**RE: ENGINEER CERTIFICATION FOR NEW MEXICO DESIGN (C-17/D2A26A)
CERTIFICATION STATEMENT DATED 12/4/98.**

RE: REVISED DRAINAGE PLAN FOR NEW MEXICO DESIGN (C17-D2A26A)
REVISION DATED 9/12/97

Re: **New Mexico Design Center; Grading and Drainage Plan (C17-D2A27)**

Re: New Mexico Design Center; Grading and Drainage Plan (C17-D2A26A)

OUTFALL CHANNEL

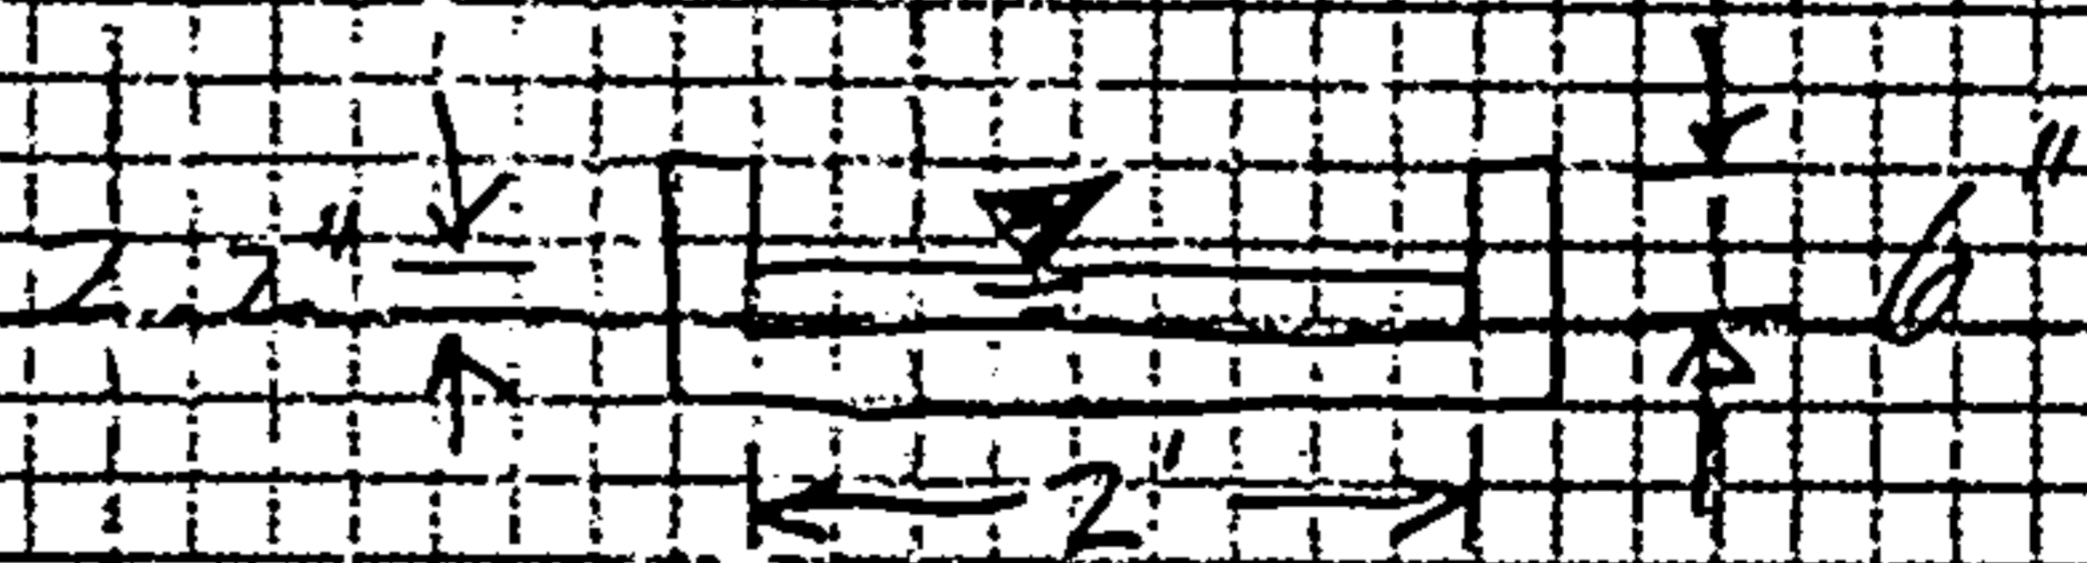
ATMAD predicts a maximum discharge from this site of 5.6 cfs during the 100 yr storm. From where on-site discharge emerges to the open channel (2' x 6"), there is a slope from elev. 20.13 to elev. 15.50 of 21%. From elevation 15.54 to Columbine Ave. the slope decreases to approximately 2%. Does a hydraulic jump occur at this transition?

What is the flow characteristic in the lower channel reach where the slope decreases to 2%?

Therefore, depth of flow is below d_c and remains super critical.
NO HYDRAULIC JUMP!
